HISTORIC PRESERVATION COMMISSION

STAFF REPORT Department of Growth Management

MEETING DATE:	January 6, 2015
PROJECT:	Lot 1D, (36 Promenade Street) Calhoun Street Promenade – New Construction
APPLICANT:	Ludtke & Vaccaro Architects, LLC.
PROJECT MANAGER:	Erin Schumacher, Senior Planner

PLAN REVIEW COMMENTS FOR COFA-11-15-009421

③ Typical Window Section
 3" = 1'-0"

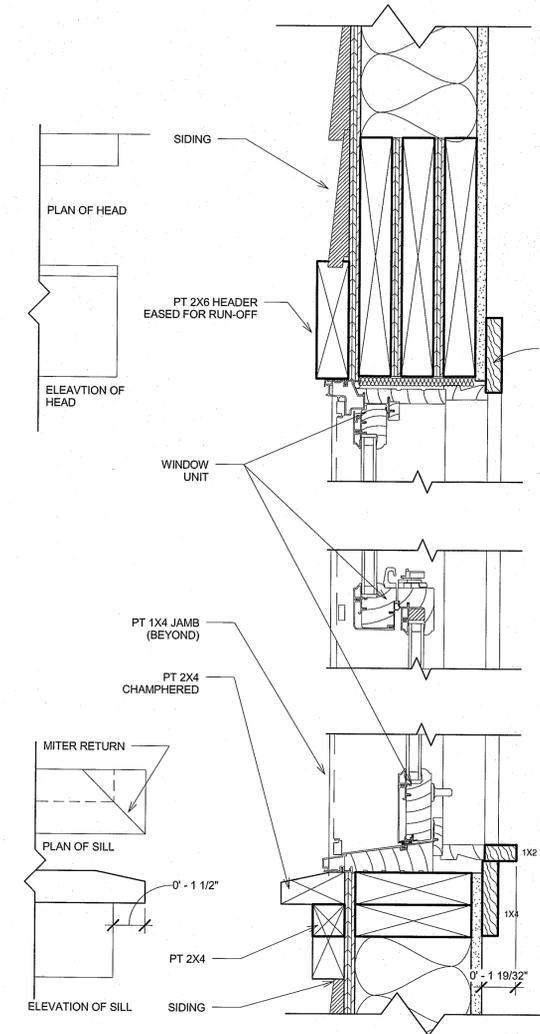
- General drafting comment: All double hung windows, although being seen from the exterior, are showing an interior view. The check rail, should be adjusted so the top sash is in front of the bottom sash.
